**ARCHITECT'S ADDENDUM**

Addendum Number: 03

Transportation Center

Subject: Addendum No. 03 to the Construction Documents for the Fort Zumwalt School District Transportation Center

1 FLOOR PLAN - LEVEL 01  
A2.01 1/8" = 1'-0"

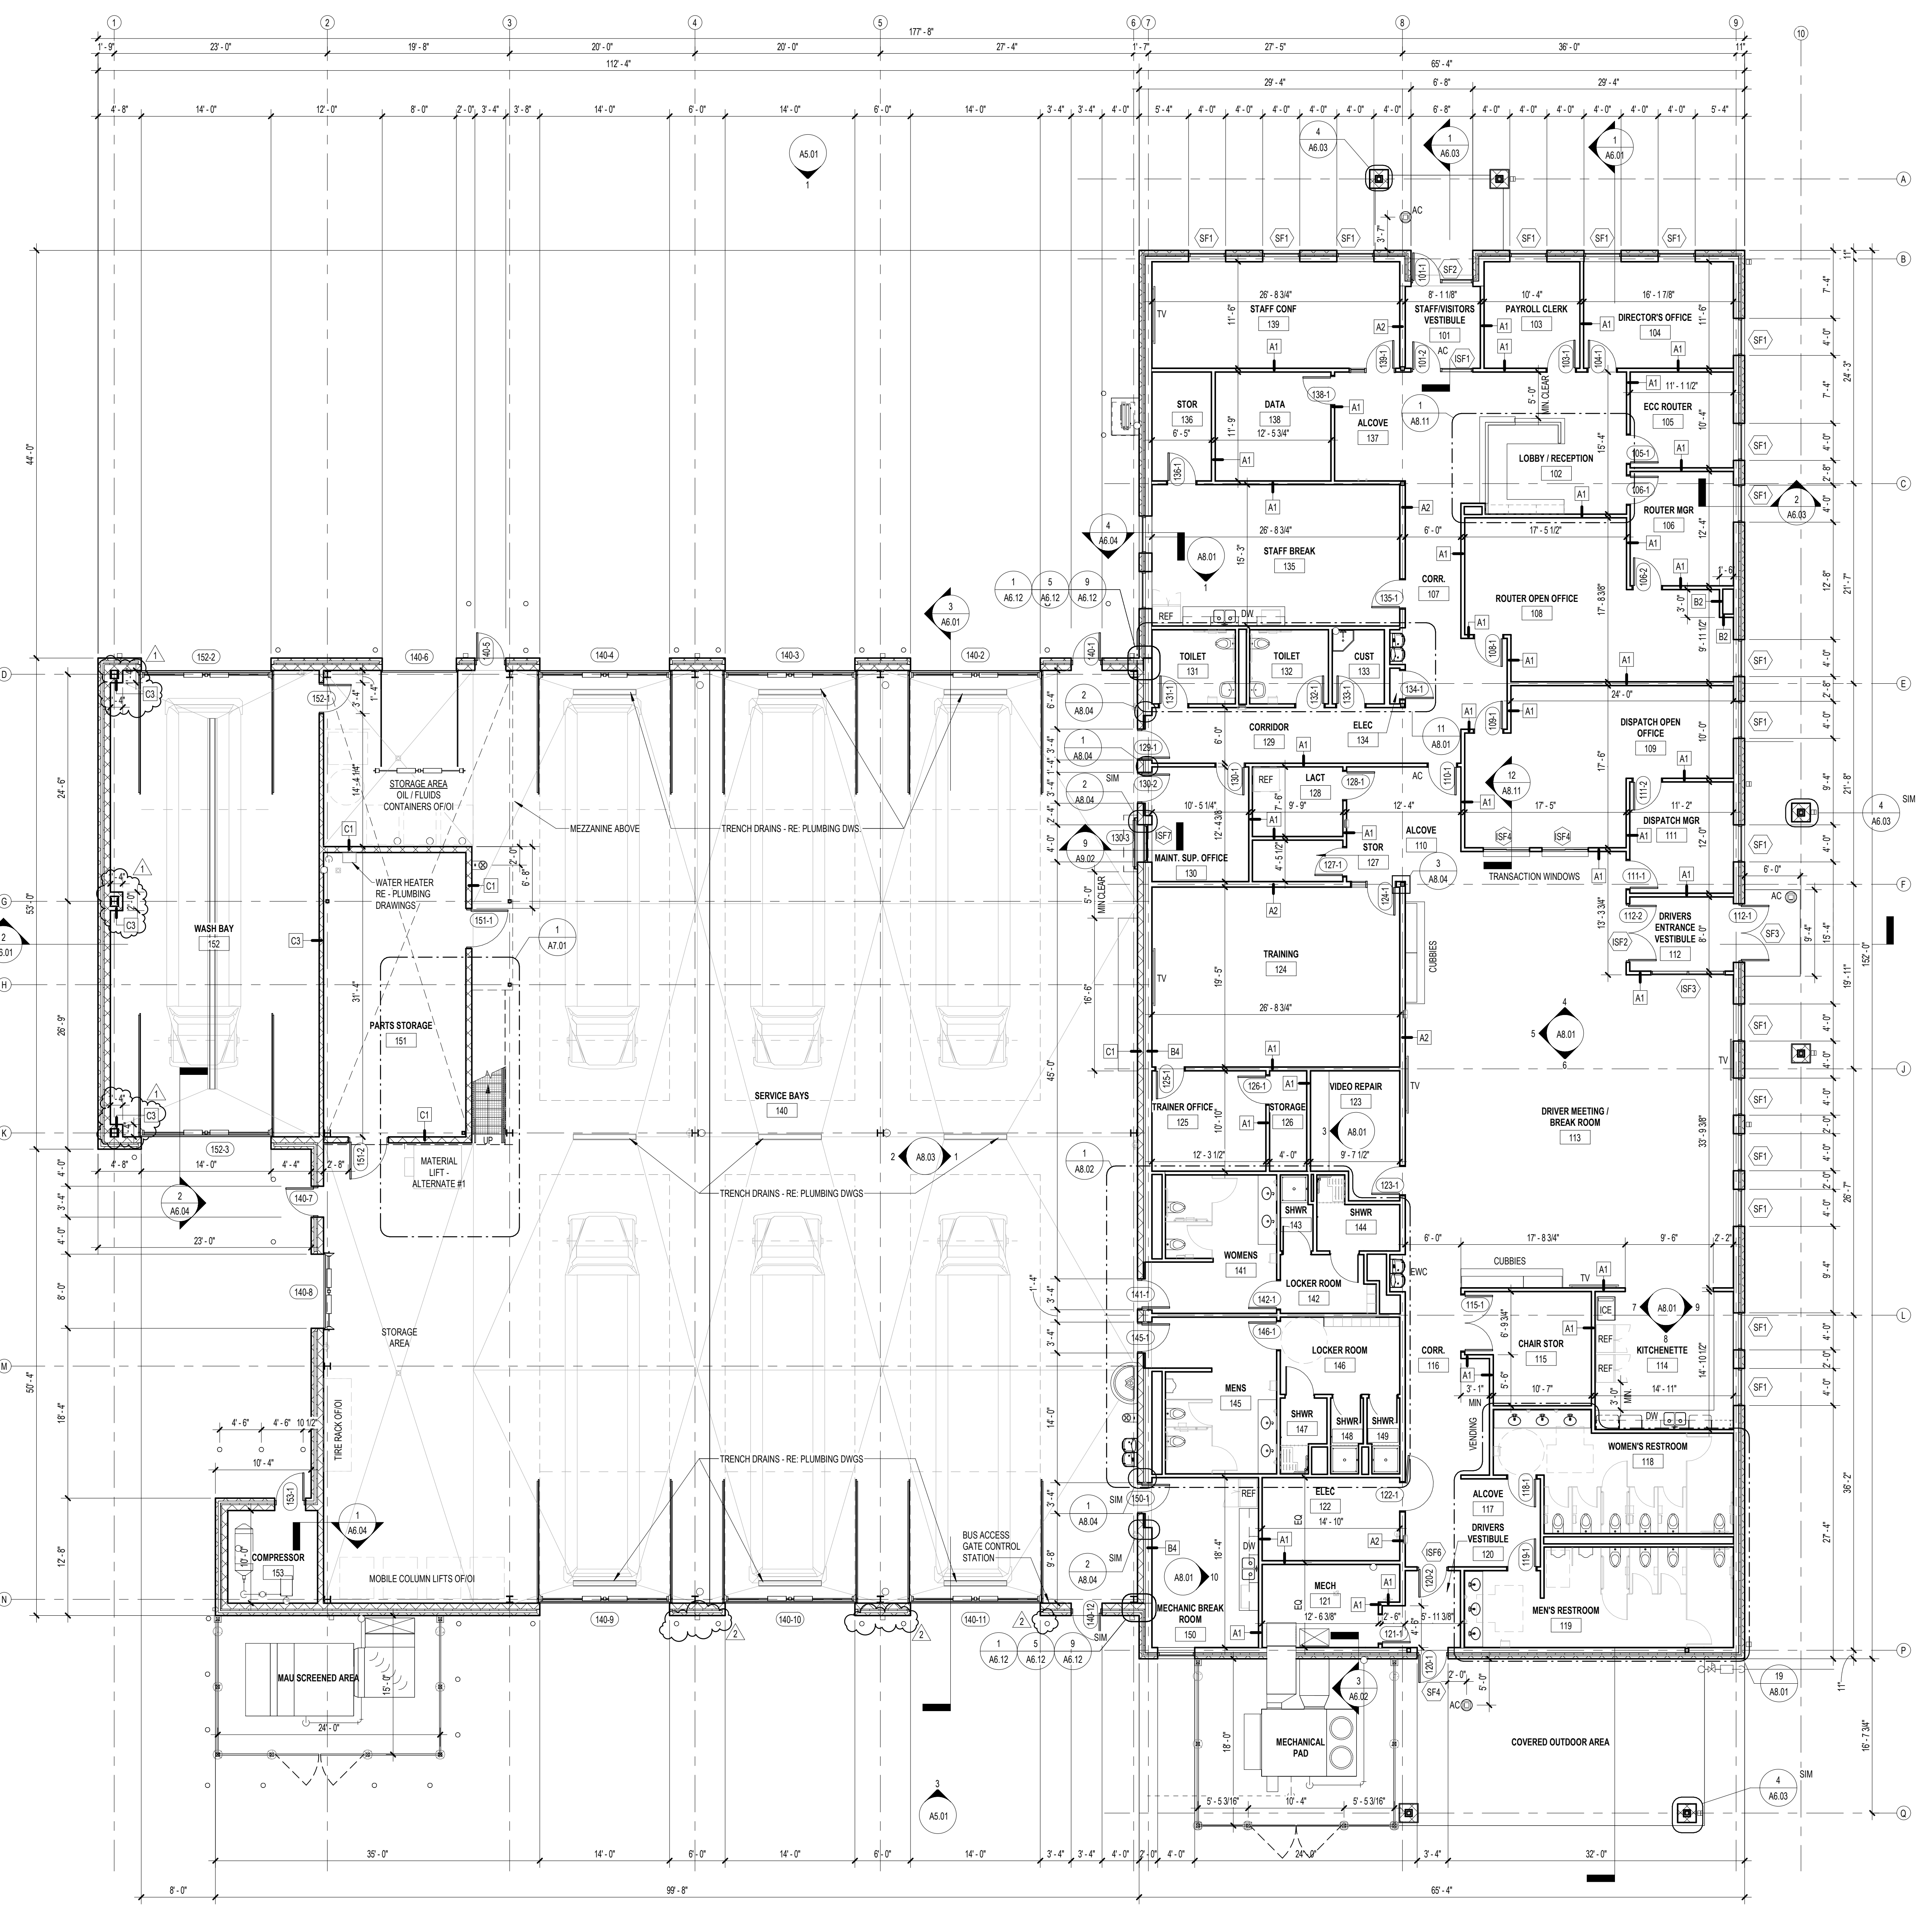
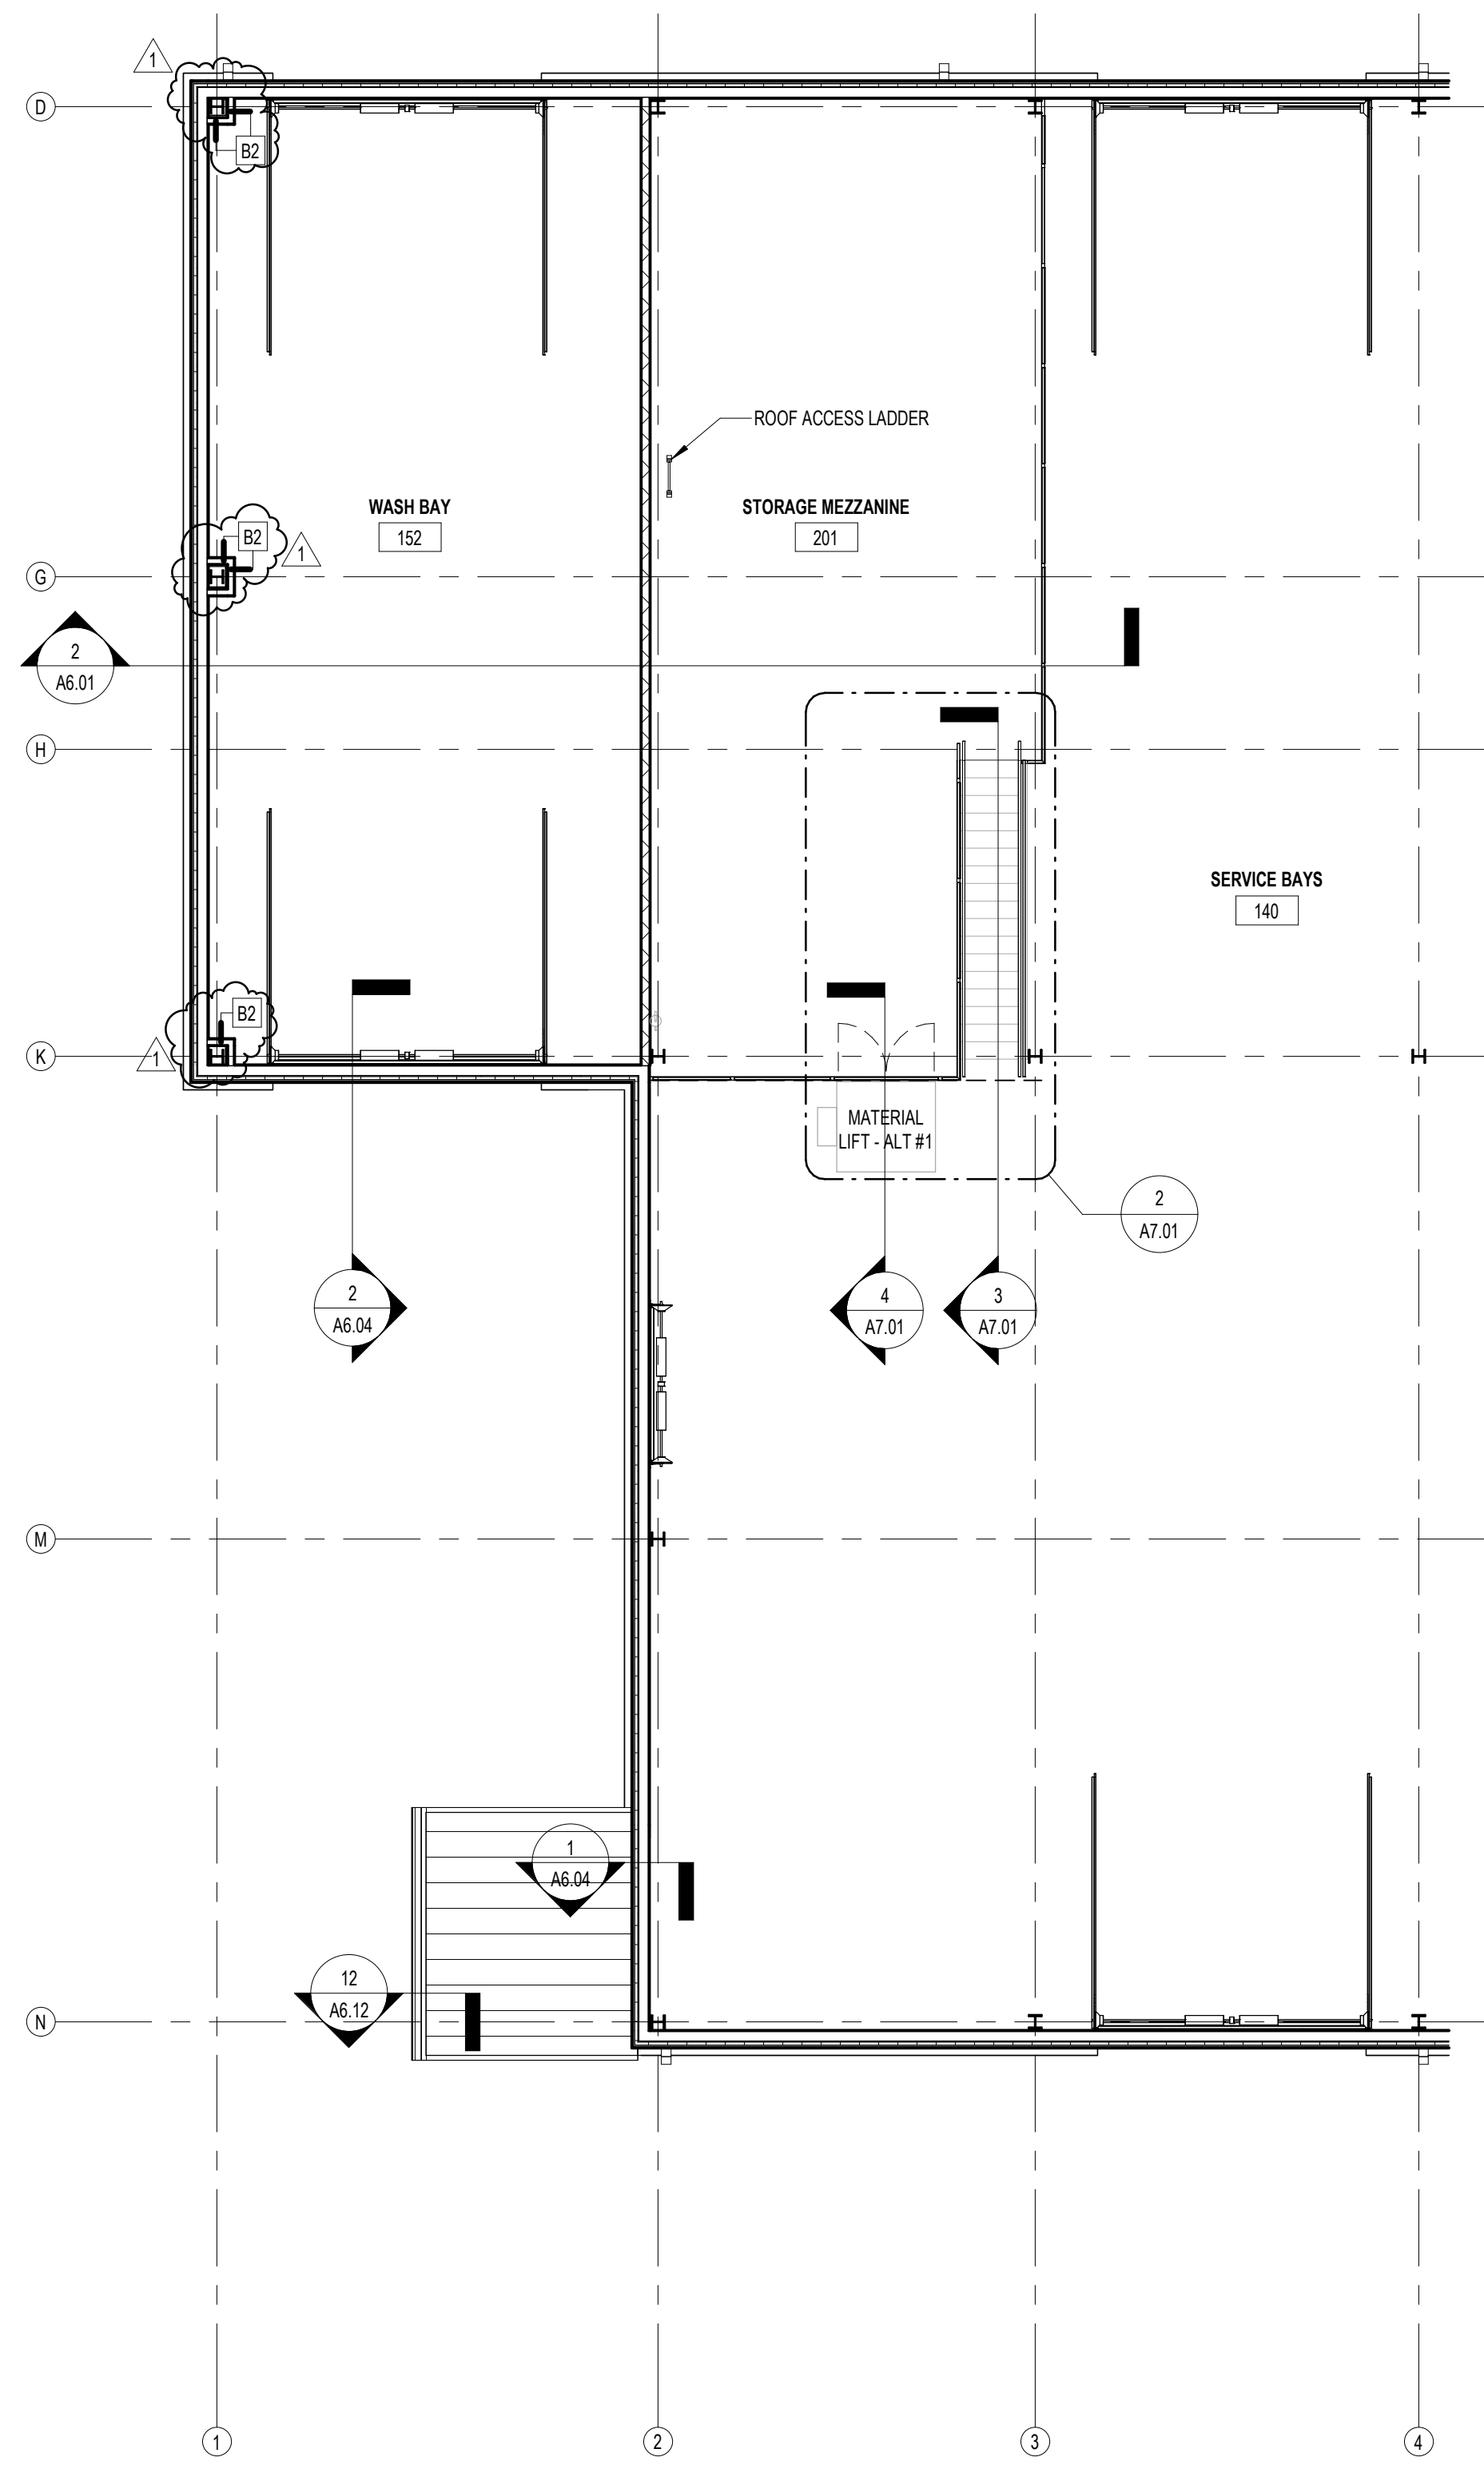
Q – The architectural floor plan and elevations do not show bollards at the (3) OH doors on the South elevation. However, there's a note on the elevations calling these out, but doesn't show the bollards. My question is, is the intent to match the bollard layout of the (3) OH doors on the North elevation? Or are bollards not required at the OH doors on the South elevation?

A – *Bollards are required at both the north and south elevations. The layout at the south elevation should be the same as the north elevation. See revised sheets this addendum.*
